Access Compliance Report Public Rights-of-Way (Pedestrian Signals)

Main Street: ORTEGA_HWY Cross Street: AVENIDA_LA_PATA Location: SE

ADA ID: SGRK211122144422 Signal Type: One Push Button-Non APS Overall Compliance: No Severity Scores: BTN 1: 10 BTN 2: N/A No BTN: N/A

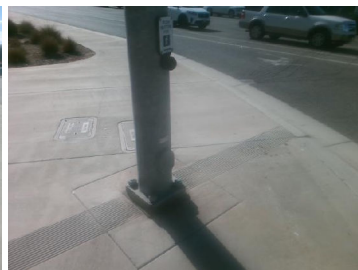
Possible Solutions: Replace Signal Push Button With APS Button. Remove & Relocate Sign.
